T.I. no.: 2019 - 10 Updated: -	Topic: Loose beverage outlet and user panel bracket screws
---	---

Date: 25.06.2019
Affected machines: SC Soul
From serial number: -
As of date: -

View of rear side with M4x18 (060543)

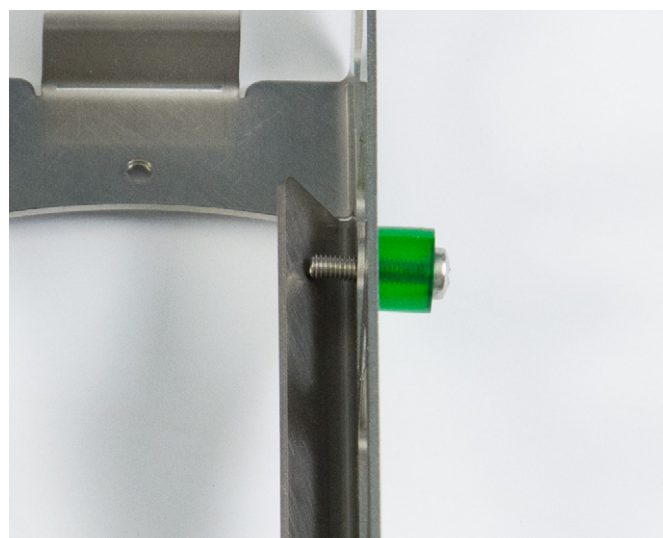
Due to insufficient screw lock, screws can loosen at the sides of the beverage outlet and user panel brackets over time.

Beverage outlet bracket

In affected machines, treat the long M4x18 (060543) screws with screw lock and tighten. The screws can be ordered for free from Schaerer AG until 31/12/2019.

The assembly process has been adapted. For machines starting with serial number 1921.../, the screws do not loosen.
